TR-150640
Revised engineering
Plans -
bungalow

From: Terrel A. Anderson <TAANDERS@UP.COM>
Sent: Tuesday, April 21, 2015 10:55 AM
To: Hunter, Kathy (UTC)
Cc: Curl, Paul (UTC); Mike A. Smith
Subject: RE: Park Rd application to replace existing cantilever with flashing lights with gates
MP5.63 Spokane Valley DOT#662510F Spokane Sub
Attachments: Park RD.pdf; Signed application.pdf

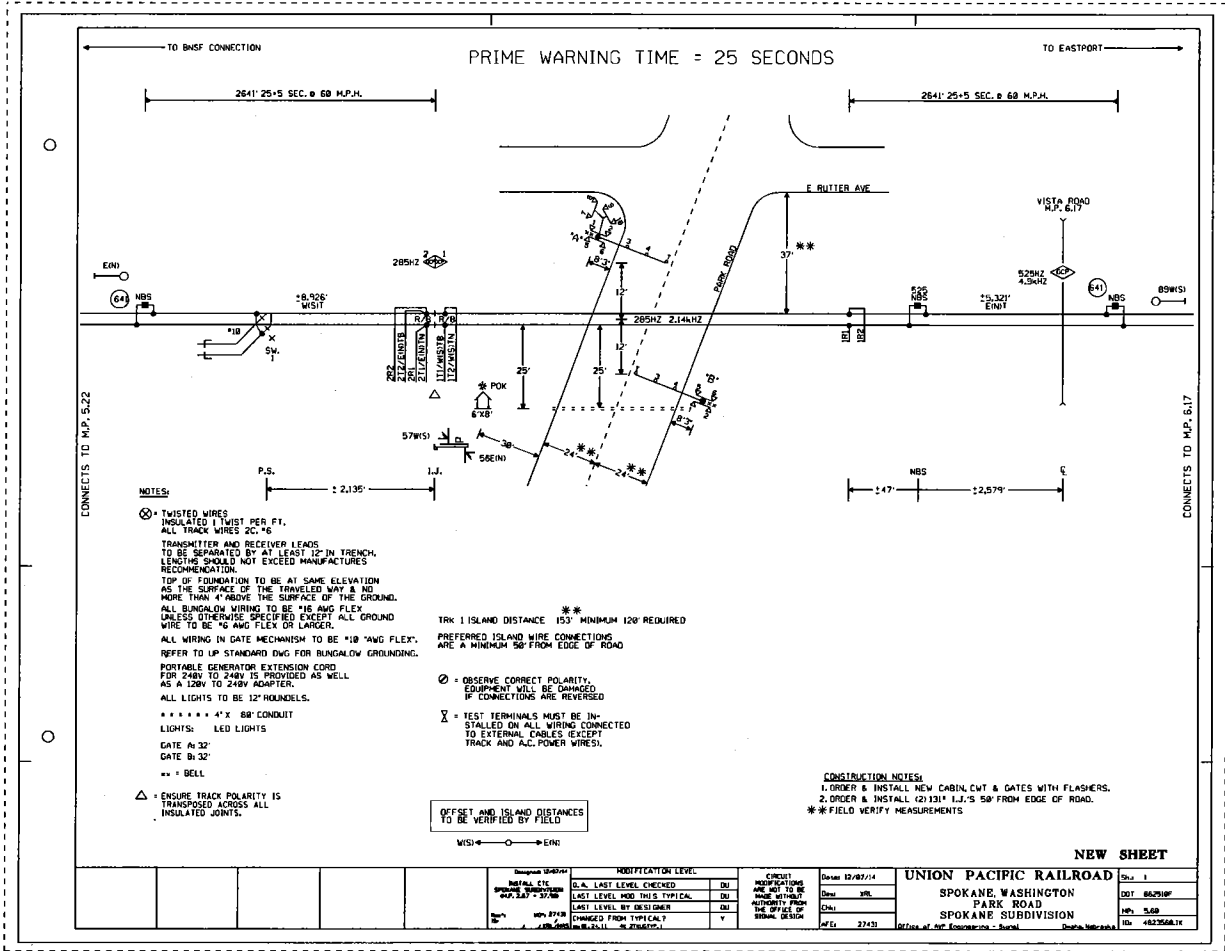
The house is currently in the NE quad and will be relocated to the SE quad.

The Sight distance for a vehicle stopped at "A" Gate North 2,400' South 4000'

The Sight distance for a vehicle stopped at "B" Gate North 2,400' South 4000'
